PLANNING AND ZONING COMMISSION AGENDA

Wednesday, March 12, 2025
7:00 PM
Yorkville City Hall Council Chambers
651 Prairie Pointe Drive

To: Planning and Zoning Commission
From: Sara Mendez, Planner I
CC: Bart Olson, City Administrator
Krysti Barksdale-Noble, Community Development Director
Date: February 21, 2025
Subject: **PZC 2024-22 Beecher Road Solar, LLC (Expansion)/Nexamp – Solar Farm**

Solar Setbacks

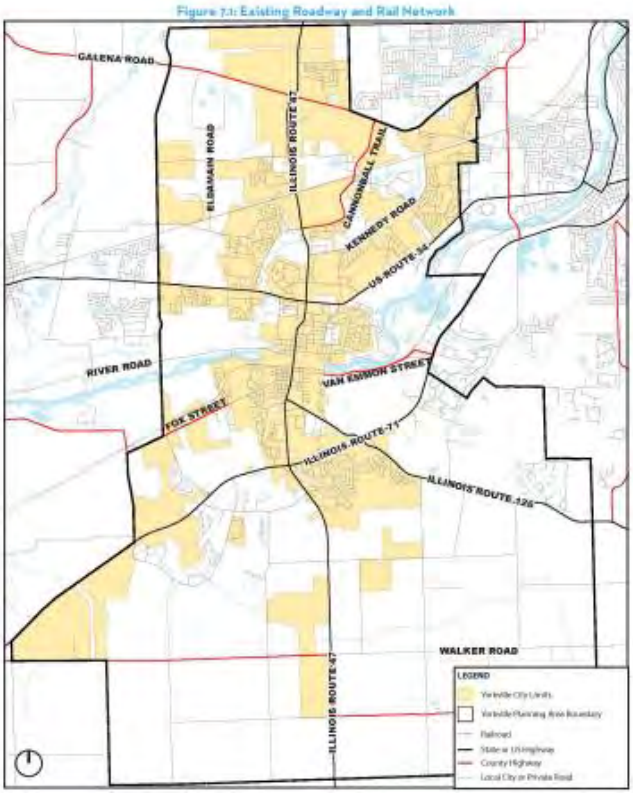
The location of the solar panels meets the side (east and west) and the rear (north) setbacks for the Solar Farm use in the A-1 Agricultural District. Although Section 10-4-13B.8.a of the Unified Development Ordinance states the front yard setback for the solar farm use is one hundred (100) feet, Section 10-4-13B.8.c states the buffer area from the nearest solar array to roadway networks is one thousand (1,000) feet. Therefore, the solar panels appear to encroach into required front (south) yard setback.

Section 10-4-13B.8.c of the City's Unified Development Ordinance provides buffer requirements for solar farms in relation to roadway networks and the Fox River. The proposed solar panel encroaches into the required front yard setback to the south. The ordinance requires a minimum buffer of 1,000 feet from the nearest solar array to roadway networks as defined in Figure 7.1: Existing Roadway and Rail Network of the 2016 United City of Yorkville Comprehensive Plan. Currently, Corneils Road is not designated as a major arterial roadway network in Figure 7.1.

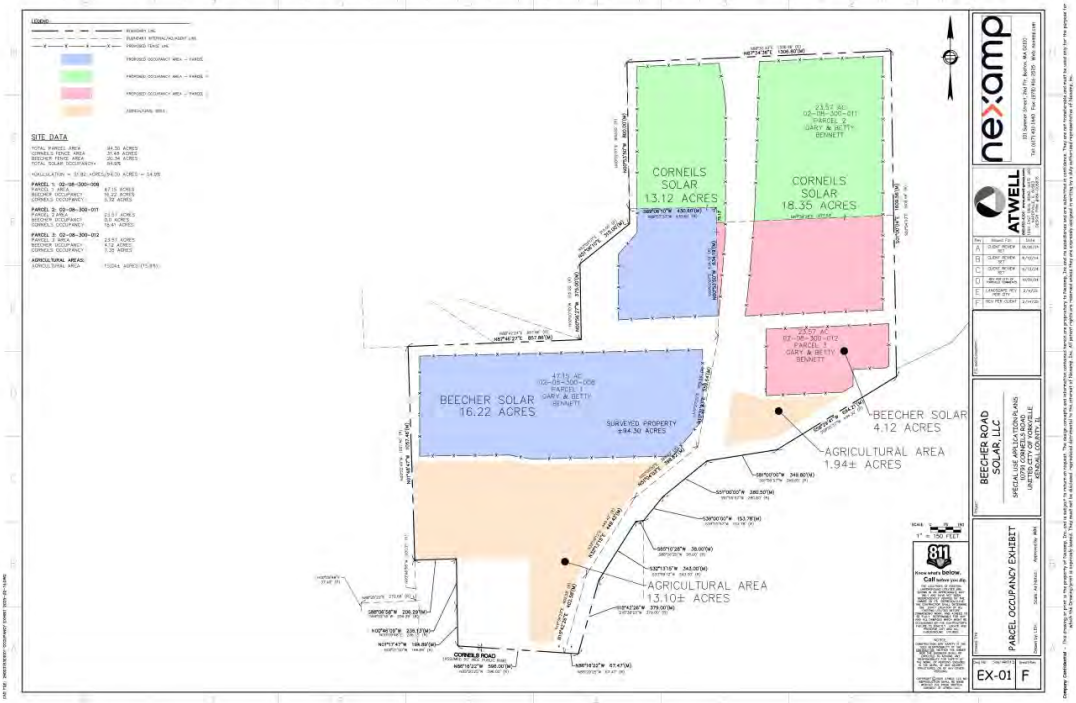
Combined the approved Corneils Road Solar and the proposed Beecher Road Solar will occupy 54.9% (51.82-acres) of the existing 94.30-acres of existing farmland. Each individual parcel associated with both solar farm projects maintains a lower occupancy percentage for the solar farm, with a greater portion remaining in agricultural use.

The first visual represents the previously submitted occupancy exhibit, illustrating the total acreage occupied by the approved and proposed solar farms for each parcel. The second visual presents the newly submitted occupancy exhibit, reflecting the updated acreage allocation.

DETAILED LANDSCAPING LAYOUT – EAST
SCALE: 1" = 50'

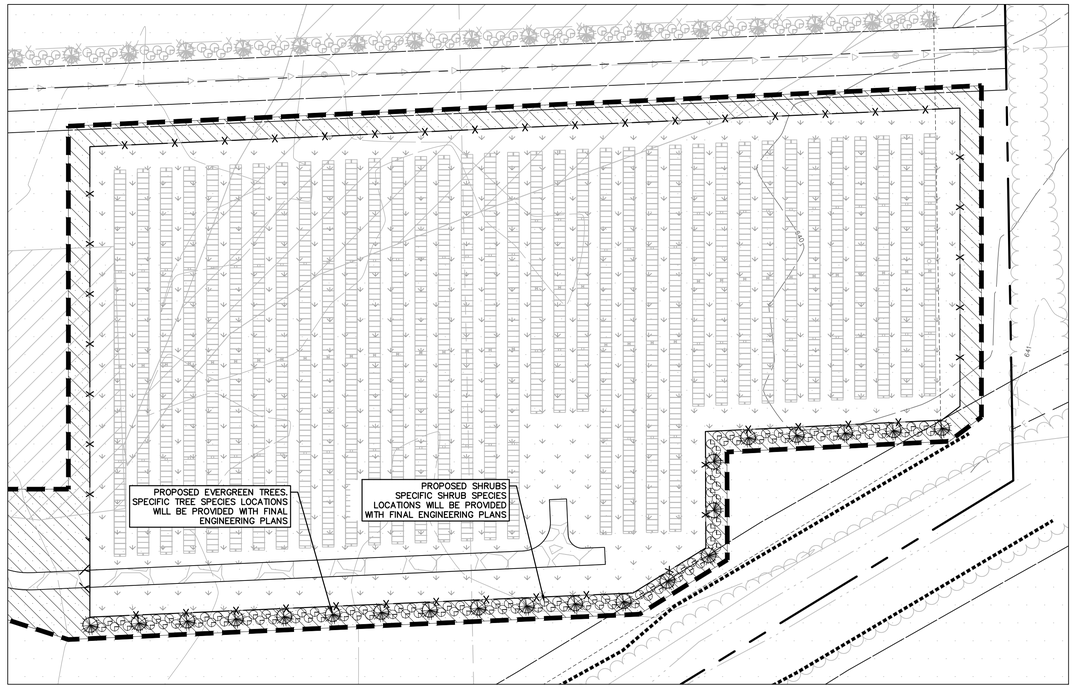
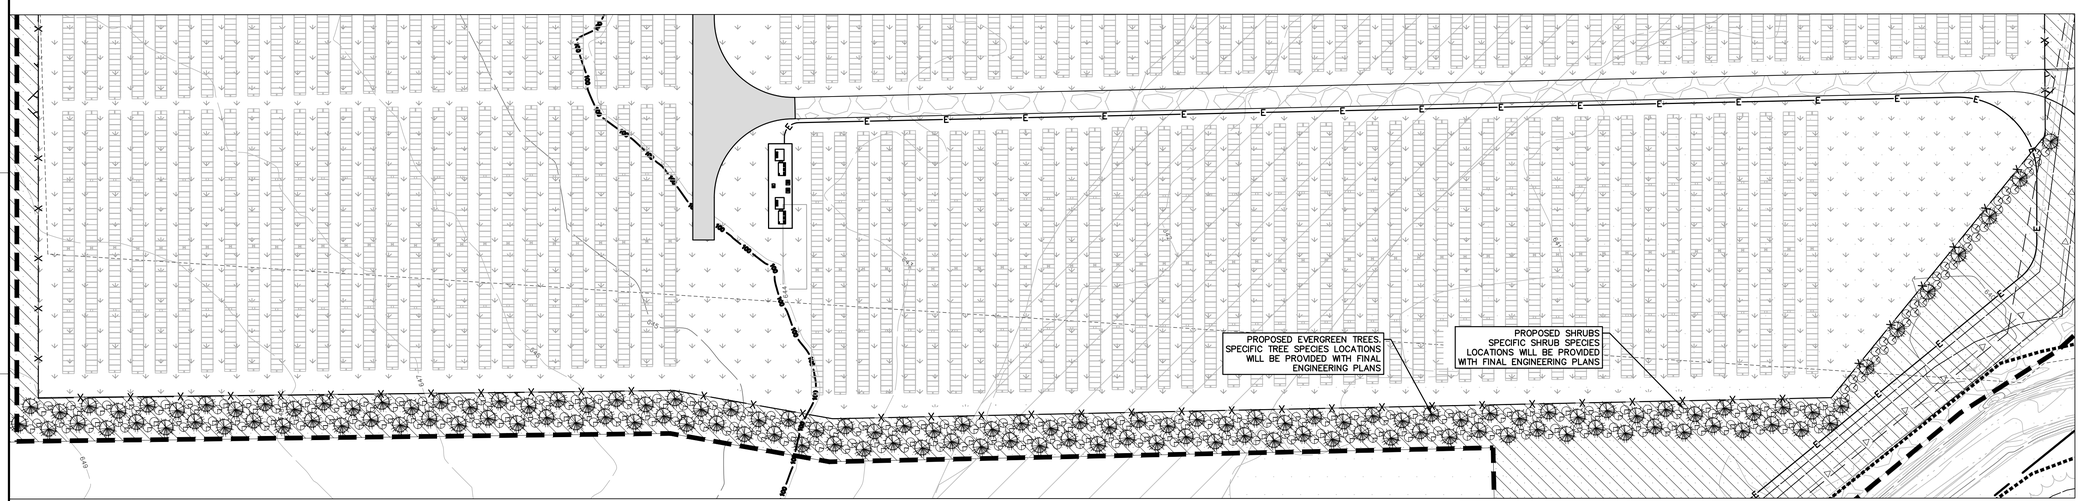
A Plant Schedule included on the Landscape Plan sheet C-400 indicates 39 evergreen trees and 195 shrubs are proposed, but these plantings were not found on the plan.

Response: **The pollinator friendly seed mix has been enlarged for readability. A Vegetation Management and Maintenance Plan will be provided with final engineering plans. A detail view of proposed landscaping layout is provided on Sheet C-401. The specific locations of the proposed species will be provided with final engineering plans.**
